Approval ID : 172304, Turner 9 /46

Application 172304 Fails To Comply

DEVELOPMENT APPLICATION NO: 201834426

Description - **PROPOSAL FOR MULTI UNIT DEVELOPMENT AND LEASE VARIATION – demolition of the existing dwelling and construction of a 3 storey dwelling comprising 7 units, basement car parking and associated works. LEASE VARIATION to remove the number of specified dwellings.**

9 FORBES STREET
BLOCK 9, SECTION 46, TURNER
EXTERNAL SERVICES PLAN

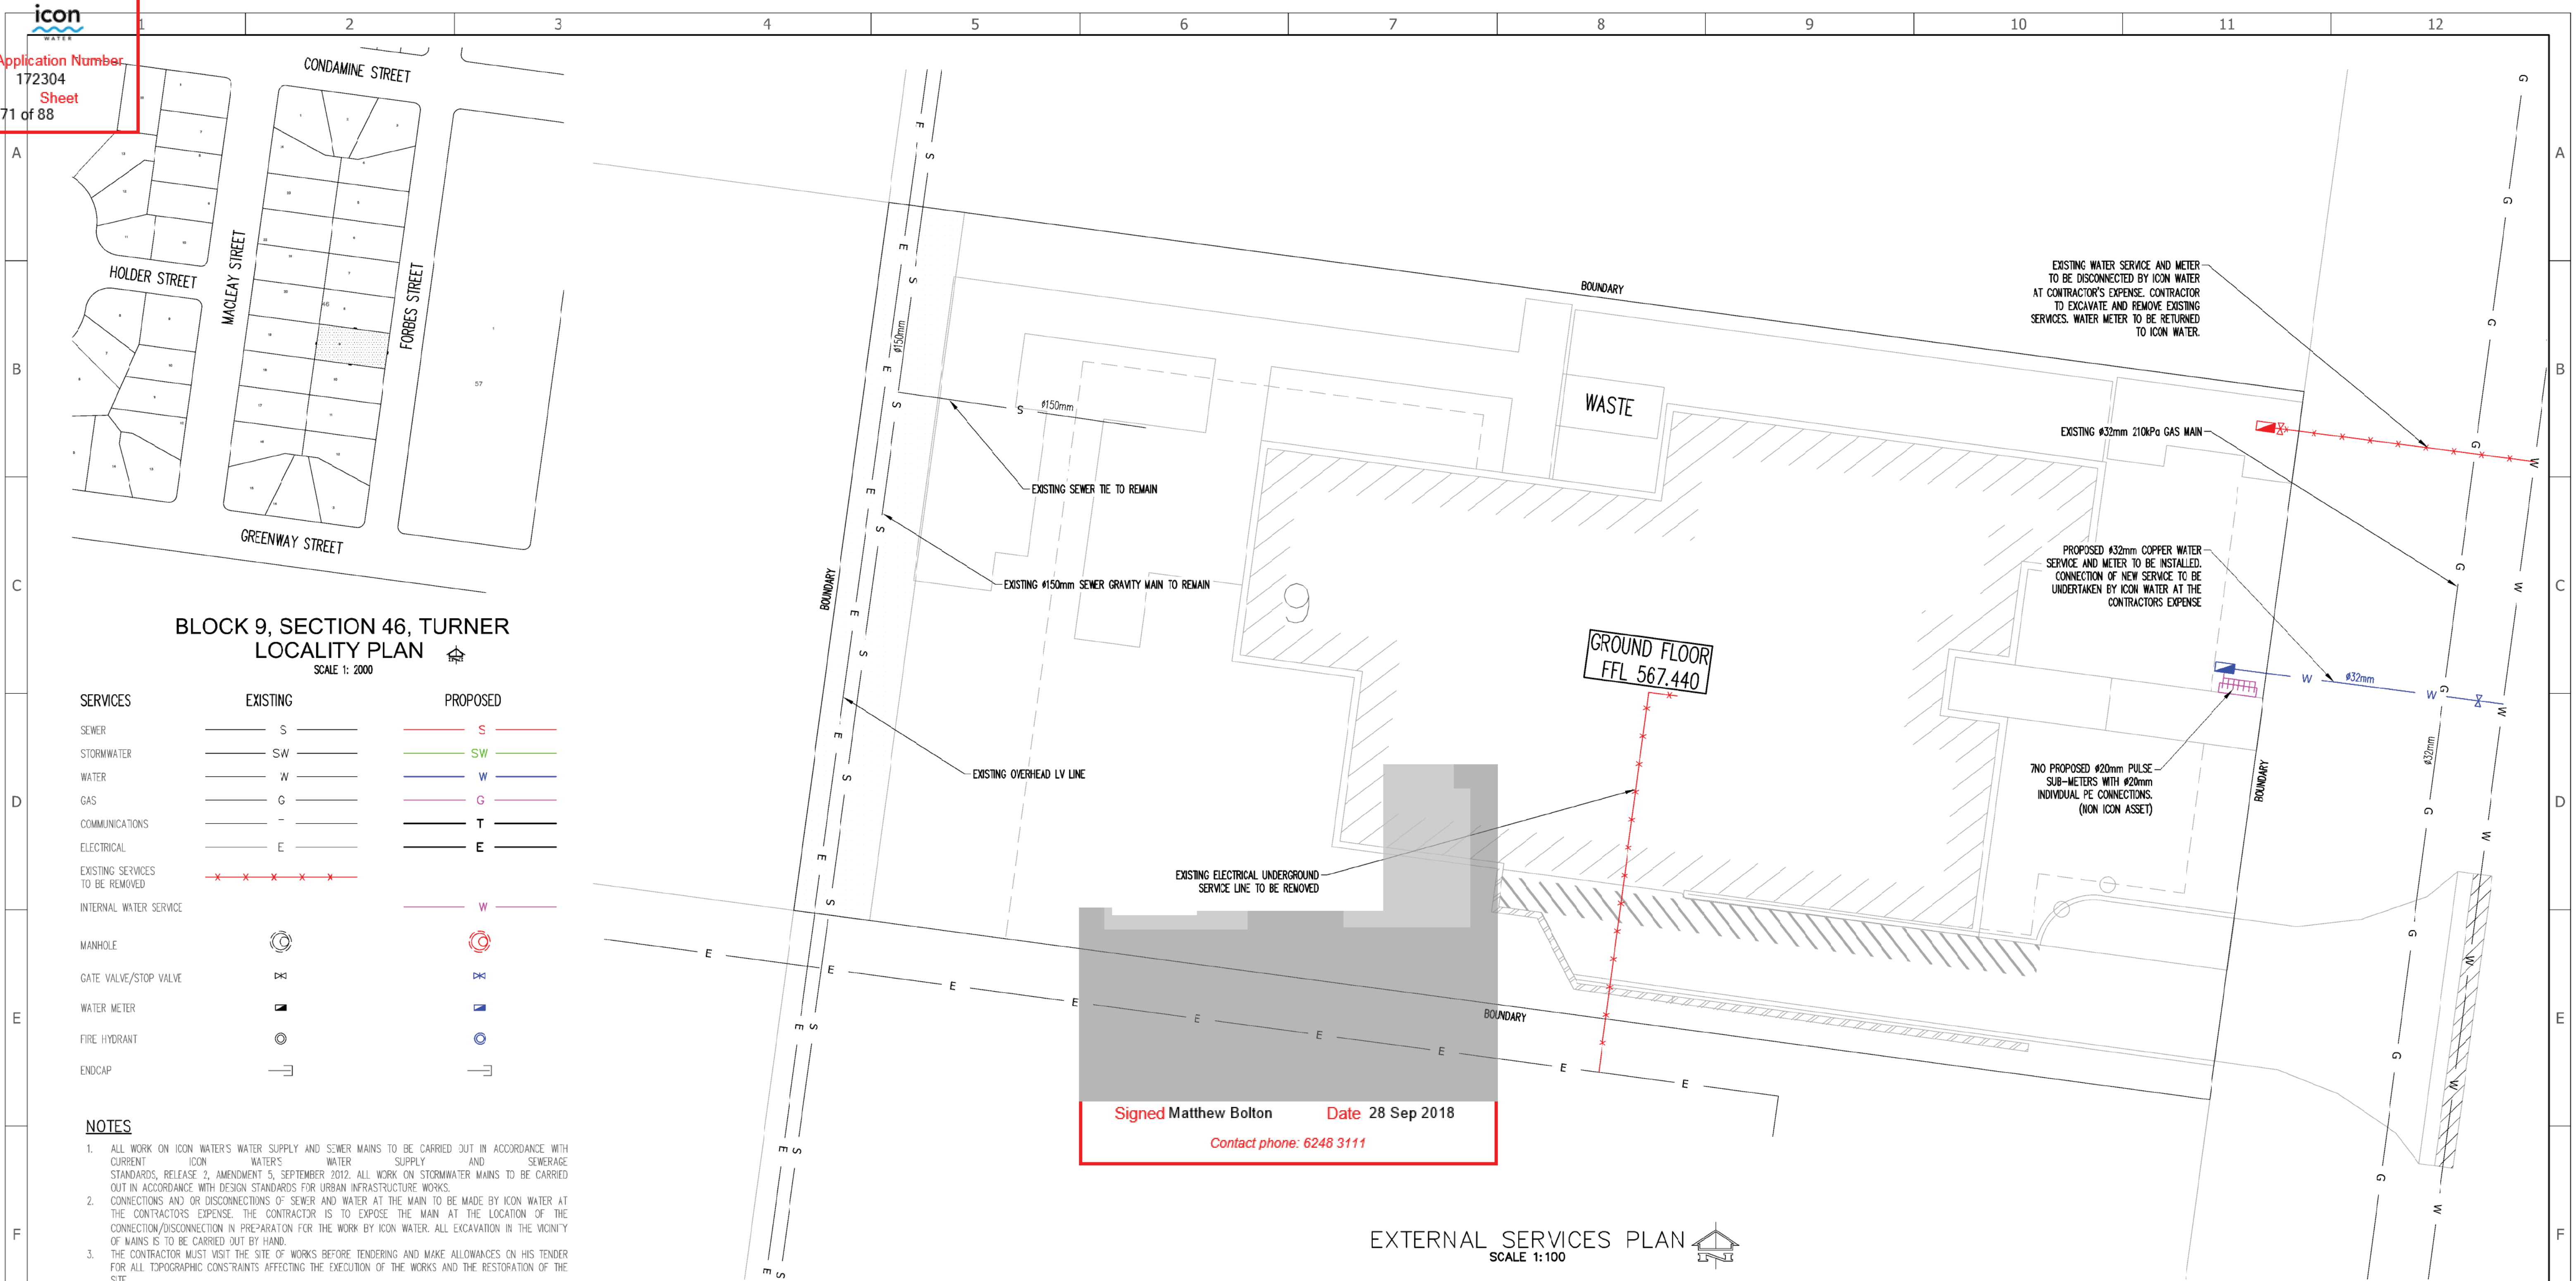
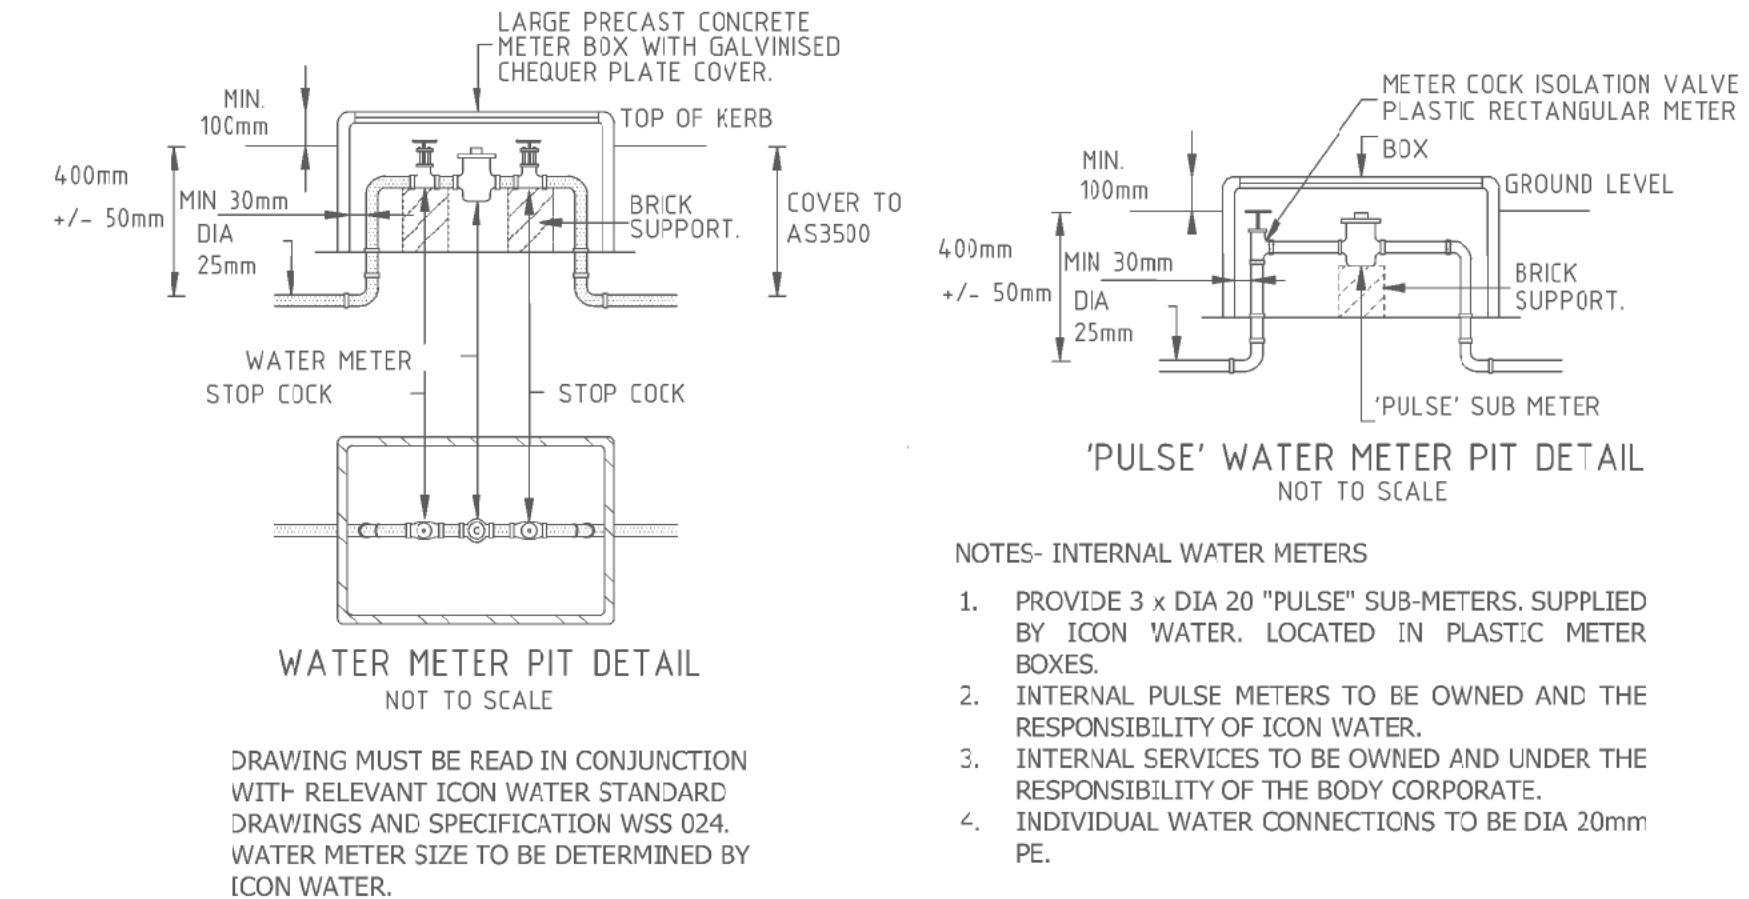
- External services plan required (for the sizing and location of water and sewerage network connections on multi- unit or commercial sites) Design Acceptance for External Services and Off Site Works must be in principle design approved by Icon Water Hydraulic Assets. Phone Icon Water Asset Acceptance on ph: 02 6248 3111 or email HydraulicAssetAcceptance@iconwater.com.au This needs to be referred back to Icon Water Building Approvals area for approval prior to any DA/BA Approval by ACTPLA or certifiers.

- Icon Water network and conections must be shown on relevant drawings.
- Rock anchor and soil nails, details need to be shown on relevant drawings.
- All excavation methods, anchor details and protections must have Hydraulic Design Acceptance prior to resubmission.
